Inspection and Replacement of Static Pressure Button

M20, Serials 1002-1200; M20A, Serials 1201-1700;

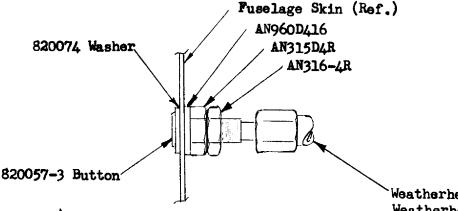
The static pressure button has been redesigned for the 1964 model Mooney aircraft and is offered as a replacement for earlier models. The new button provides more positive attachment and sturdier construction. It is recommended that this new button be installed if the following inspection shows it necessary.

- 1. Remove radio access door from left side of fuselage.
- 2. Physically check both static pressure buttons securely attached to fuselage. If either is loose, install this kit as follows:
- 3. Remove both buttons from fuselage by disconnecting from fitting and removing Tinnerman fastener.
- 4. Drill out the existing mounting holes in the fuselage to .25 to allow insertion of the new static buttons.
- 5. Place the 820074 washer on the 820057 static button and insert the assembly into fuselage mounting holes: NOTE: The 820074 washers have a smaller outside diameter than the other two.
- 6. Place the larger washer, the larger nut, and the check nut on the static button. Run the two nuts down against the fuselage finger tight, by holding the end of the static button.

- 7. Place the nut from the existing brass union and a new sleeve on the end of the static button and tighten.
- 8. Using the nut on the union for wrenching flats, tighten the larger nut down tight against the fuselage. Now bring the check nut up tight against the first nut. Repeat procedure for the other side.
- 9. Replace radio access door.
